TB 121

TECHNICAL BULLETIN

Product : Midilift XL+ - Traction platform lift

Subject : Guide brackets

Example
of weld
breaking

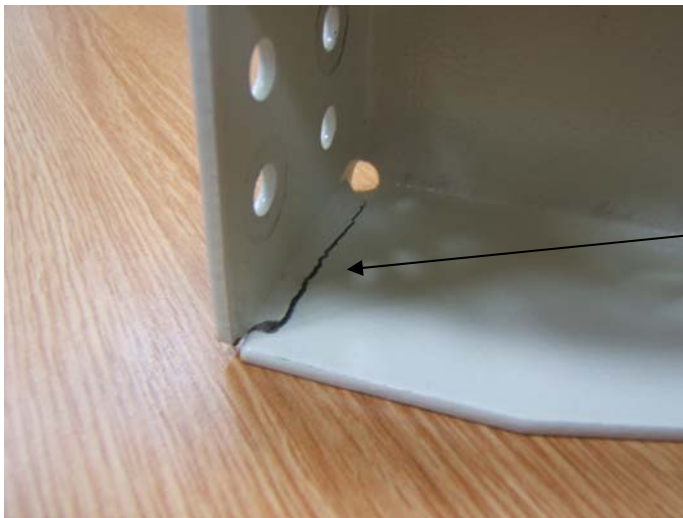
It has come to our attention that a quality issue has arisen on a batch of welded guide brackets fitted to the XL+ product. We have isolated the potentially defective parts to a given period of time, but require all lifts to be inspected.

The weld failure is not critical to the operation of the lift after handover but if identified, should be replaced. A replacement part is available free of charge from our spares department.

- An unknown quantity of sub standard welded guide brackets has been fitted to the XL+ product.
- Please visually inspect the brackets during the next service to see if there are any signs of cracking.
- To request a replacement part please contact our spares department quoting part number 6205004. The replacement will be sent out as a warranty replacement free of charge.
